UNITED STATES PATENT AND TRADEMARK OFFICE

APPLICATION NO.	FILING DATE	FIRST NAMED INVENTOR	ATTORNEY DOCKET NO.	CONFIRMATION NO.
10/018,596	03/14/2002	Gerhard Rinninger	15028	8380

FINAL REJECTION

Fig. 1 of Becker et al. ('541)

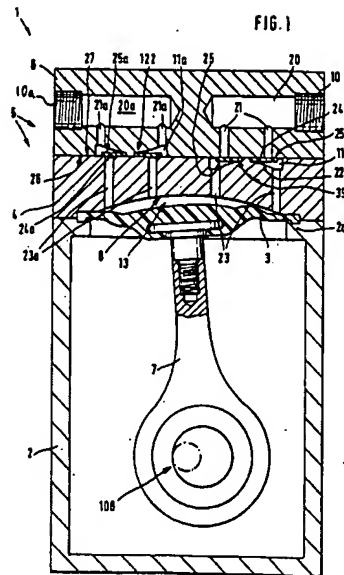
With respect to claim 19, **Becker et al.** teach a pump having a membrane M actuated by a crank drive, said membrane bounding in conjunction with a concave pump body surface BS, a pump chamber 13, an inlet channel 21, 23 and an outlet channel 24a, 23a which open to respectively an inlet opening and an outlet opening in the pump body surface, said membrane having a membrane core and an elastically deformable membrane ring MR, said membrane core having a convex surface, which is conformed to the pump body surface, said inlet opening being arranged in a region of the pump body surface which the membrane initially approaches during an expulsion stroke of the crank drive and wherein the elastically deformable membrane ring closes the inlet opening before the reaching of top dead center of the crank drive, and wherein an inlet valve 24 is provided which is arranged in the region of the inlet opening of the inlet channel, characterized in that in an edge region of the inlet opening, there is formed a surrounding control edge against which the elastically deformable membrane ring bears so as to close the inlet valve. See particularly **Figure 1**.

With respect to claim 21, **Becker et al.** teach that the middle point of the inlet opening is located at least approximately in the plane of rotation of the crank of the crank drive. See particularly **Figure 1**.

With respect to claim 24, **Becker et al.** teach that the middle axis of the inlet channel is orientated perpendicularly to the pump body surface. See particularly **Figure 1**.

With respect to claim 25, **Becker et al.** teach that the outlet opening of the outlet channel is arranged in a region of the pump body surface which is last approached by the membrane and which is reached earliest by the membrane at the top dead center of the crank drive. See particularly **Figure 1**.

With respect to claim 26, **Becker et al.** teach that the middle point of the outlet opening of the outlet channel is arranged in an inner region of the pump body surface 4 which is located opposite to the membrane core of the membrane 2. See particularly **Figure 1**.

On page 7 last paragraph of the response, applicant argues with regards to the reference Becker et al. ('541) "*the inlet and outlet channels extend directly into the pumping chamber without having an edge surrounding the region where the channels reach into the chamber as in the present invention*". Examiner disagrees because Becker ('541) does teach that the inlet and outlet channels have an edge (area surrounding opening) surrounding the region where the

channels reach into the chamber as in the present invention. See **Figure 1** of Becker et al. ('541).

On page 8 first paragraph of the response, applicant argues with regards to the reference Becker et al. ('541) "*the valves are not closed by the diaphragm*". Examiner disagrees because Becker ('541) does teach that the inlet valves are closed when the diaphragm performs a compression stroke and the outlet valves are closed when the diaphragm performs a suction stroke. See **Figure 1** of Becker et al. ('541).

Figs. 1 and 3 of Becker ('156)

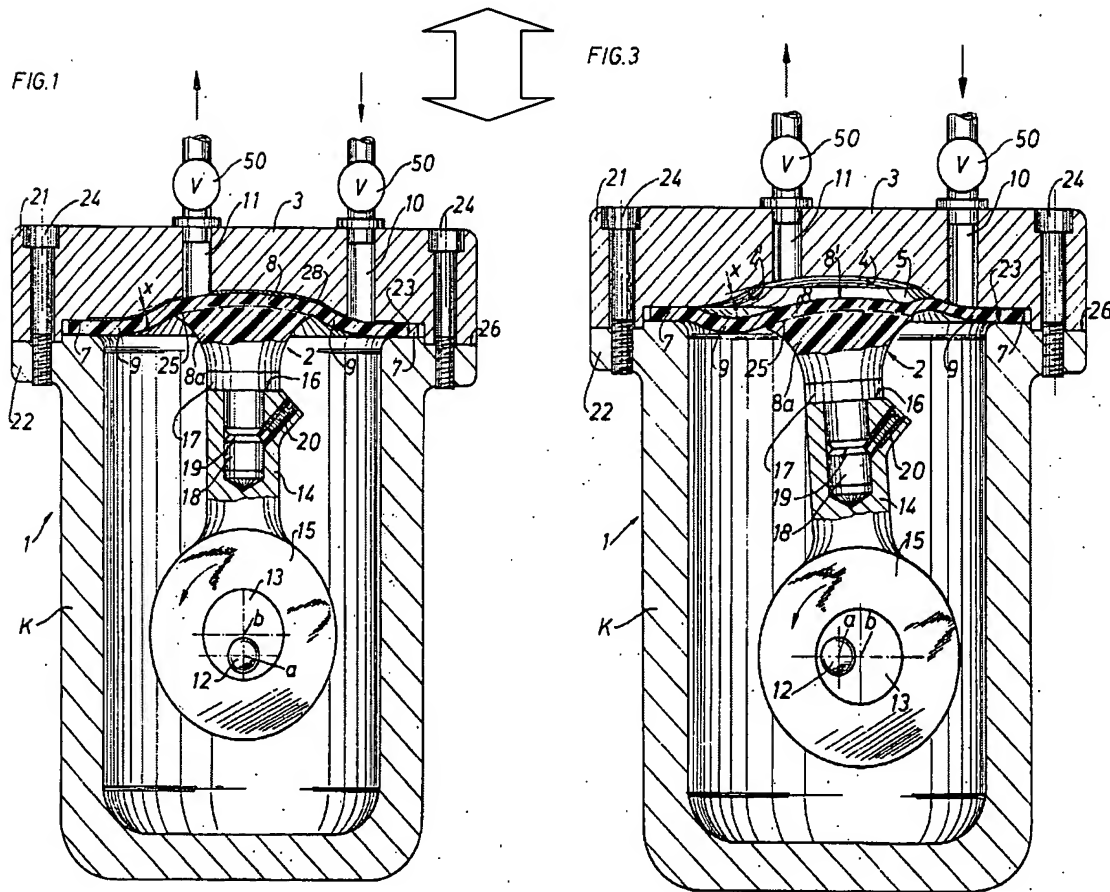
With respect to claims 22 and 23, **Becker et al. ('541)** do not schematically show that the elastically deformable membrane ring closes the inlet opening at a rotary cranking position of the crank drive which is at an angle of up to 90 degrees or within the range of about 20 degrees to 90 degrees before top dead center. However, Becker ('156) teaches a similar apparatus to Becker et al. ('541). Further, Figures 1 and 3 of Becker ('156) teach that it is obvious if not inherent that the that the elastically deformable membrane ring closes the inlet opening at a rotary cranking position of the crank drive which is at an angle of up to 90 degrees or within the range of about 20 degrees to 90 degrees before top dead center. Notice that **Figure 1** is the TDC position while **Figure 3** is 90 degrees before TDC. To see this, refer to the location of the axes **a** and **b** corresponding to elements 12 and 13 respectively. As you can see from **Figure 3**, axis **a** and **b** are 90 degrees before TDC. See particularly **Figures 1, 3 of Becker; Figure 1 of Becker et al.** and compare the location of elements **a** and **b**.
